UNITED STATES PATENT AND TRADEMARK OFFICE

APPLICATION NO.	FILING DATE	FIRST NAMED INVENTOR	ATTORNEY DOCKET NO.	CONFIRMATION NO.
09/982,454	10/17/2001	Kiyoshi Satoh	ASMJP.100AUS	7409

Office Action Summary

DETAILED ACTION

FIG. 4.

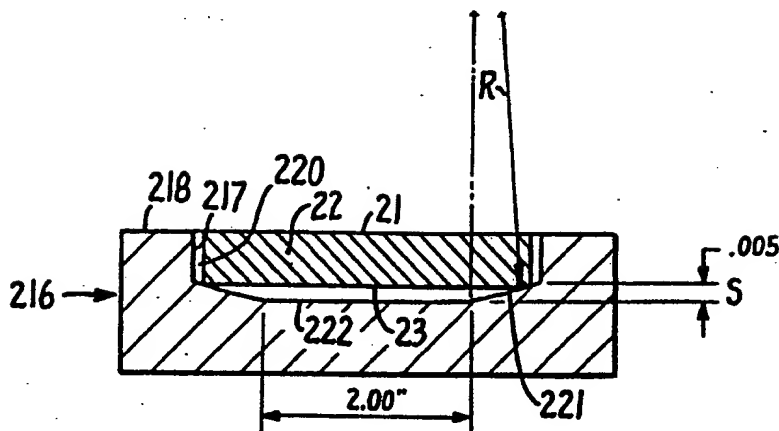
McDiarmid teaches various designs for the concave portion of the susceptor 16. Figure 3 shows that the susceptor 116 has a spherically shaped bottom surface 119. Figure 7 illustrates that the susceptor 16 has a conically shaped bottom surface. Figures 4 and 5 display that the concave portion of the susceptors 216 and 316 has a slanting portion 221, 321 and a flat portion 222, 322. By varying the design of the susceptor's concave portion, uniform heating across the wafer is achieved.

FIG. 5.

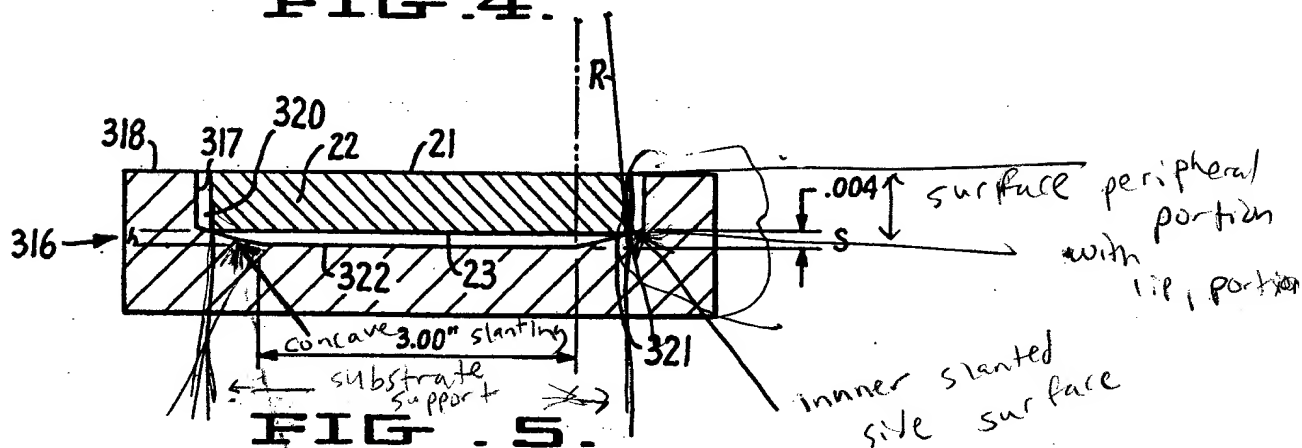
Referring to Figures 3-5 and 7, column 4, lines 6-35, 45-58, and column 5, lines 1-11, McDiarmid teaches a susceptor 16, 116, 216, 316 (substrate-supporting surface) having a concave portion. The surface 18, 118, 218, 318 (surface peripheral portion) includes a lip portion having a top surface and a slanted inner side surface. Furthermore, the surface 118, 118, 218, 318 is the same height as the wafer 22. In addition, the inner slanted side surface is slanted outward at an angle greater than the substrate-supporting surface and facing an outer edge surface of the substrate when loaded (See attached Fig. 5).

However, as seen in attached Figure 5, part of the lip portion is slanted.

As seen in attached Figure 5, part of the slanting portion 221,321 is a wafer supporting surface and part is a lip portion
